Service Bulletin

Category S	Applicable Model/s 1995 Millenia	Subject ROOF INSULATOR PEELING OFF	Bulletin No.	023/94
			Issued	6/10/94
			Revised	7/15/94

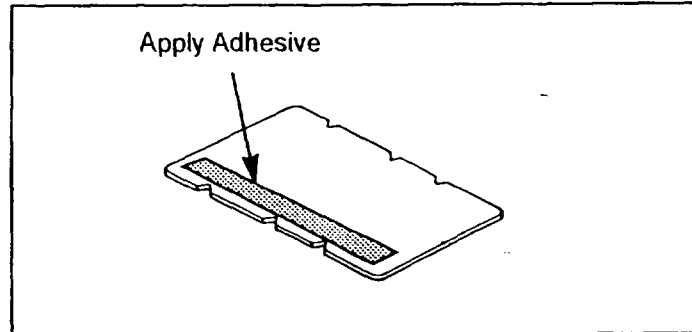
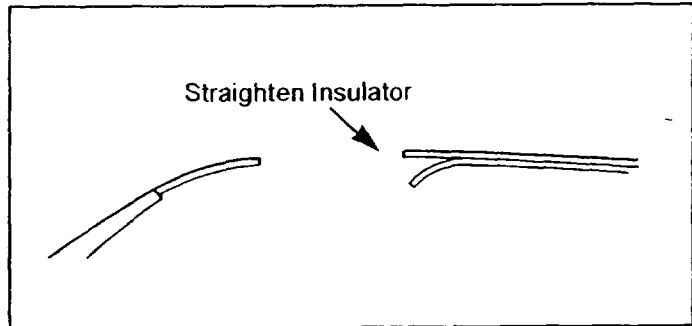
To prevent this condition, the cardboard layer between the roof panel and the adhesive has been eliminated. To improve noise insulation and adhesive properties, the thickness of the roof insulator has been increased from 6mm to 10mm and the adhesive changed (see illustration below).

Part Number		Description	Qty.	Int.	Note
New	Old				
T001 68 021C	T001 68 021A	Roof Insulator	1	A	Changed Urethane Thickness
T001 68 021D	T001 68 021C	Roof Insulator	1	AN	Changed Adhesive
